**Re:** 23 Howe Rd Special Permit # 129-16

# Consistency Ruling (#129-16) - 23 Howe Road

Severini Residence

# Approved Plans per #129-16

A3

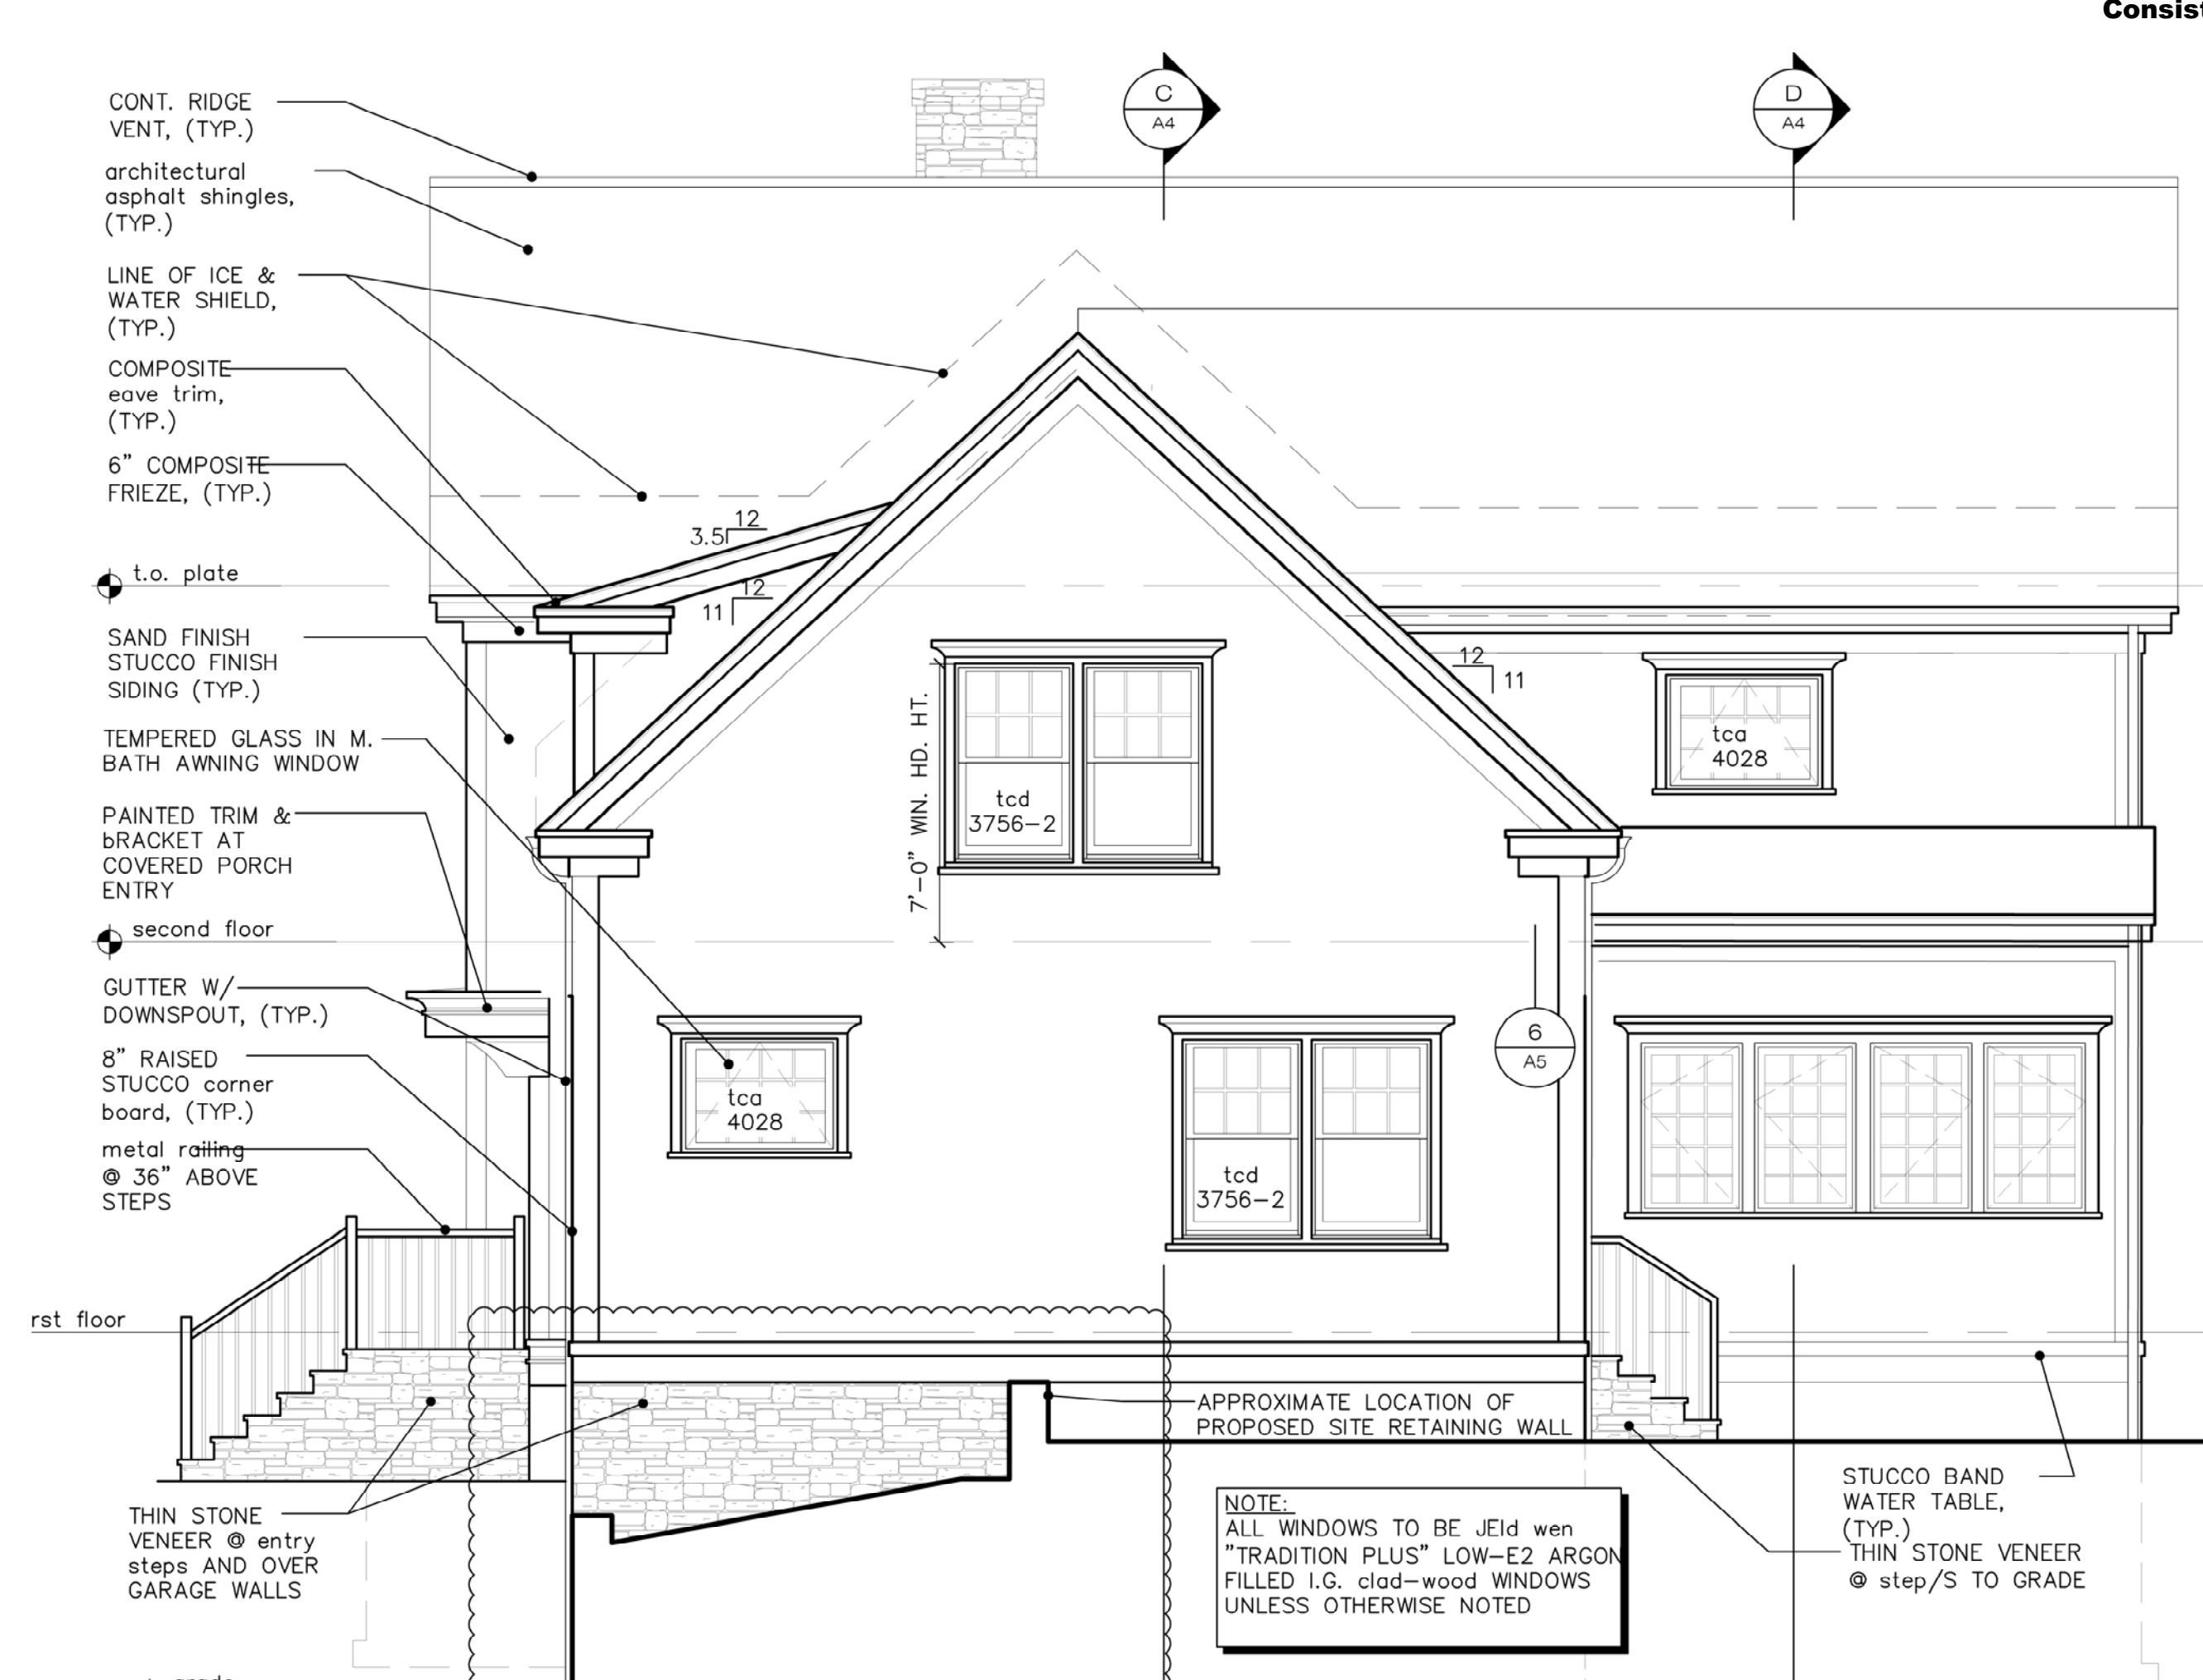
These revisions actually simplify the rooflines, remove all the dormers and any living space on the third floor. We used some of that square footage to add a small sunroom in place of a larger patio to the first and raise the roof over the kitchen, eliminating the kitchen volume ceiling in favor of adding living space in that area. The lot setbacks and height of the main ridge are unchanged. We reviewed the FAR chart and method for square footage with Anthony Ciccariello to make sure we were counting the areas properly.
